HEXAGON TRANSPORTATION CONSULTANTS, INC.

Date: November 16, 2018
To: Eilbret Mirzapour, City of San Jose
From: Robert Del Rio, T.E.
Subject: 270 West Santa Clara Street Hotel Development Traffic Operations Analysis

Subject: Almaden Corner Hotel Valet Area Analysis

Date: July 22, 2019
To: Shannon George, David J. Powers, Inc.
From: Robert Del Rio, T.E.
Subject: Review of the 270 West Santa Clara Street Hotel Valet Analysis

Figure 1: Proposed Site Plan

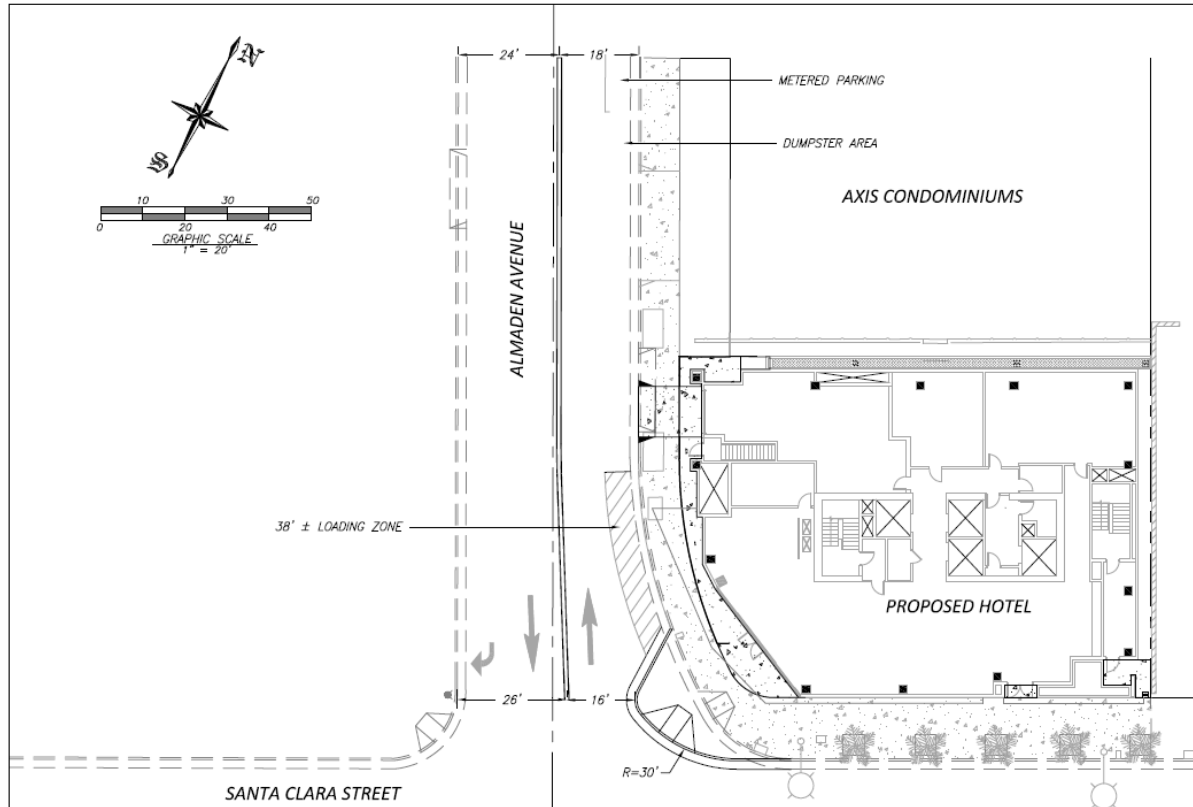
Figure 1 shows the site plan for the proposed hotel (dated March 2019). The City plans to provide a bulbout on the north-east corner to shorten the crosswalk distance on the northern leg. Two valet spaces can be provided along the hotel frontage on Almaden Avenue. The City of San Jose will also allow valet to operate on Santa Clara Street along the project frontage. Santa Clara Street will provide approximately three (3) additional valet spaces for a total of five (5) valet spaces. **Attachment A** provides a drawing with the proposed valet on Almaden Avenue and Santa Clara Street.
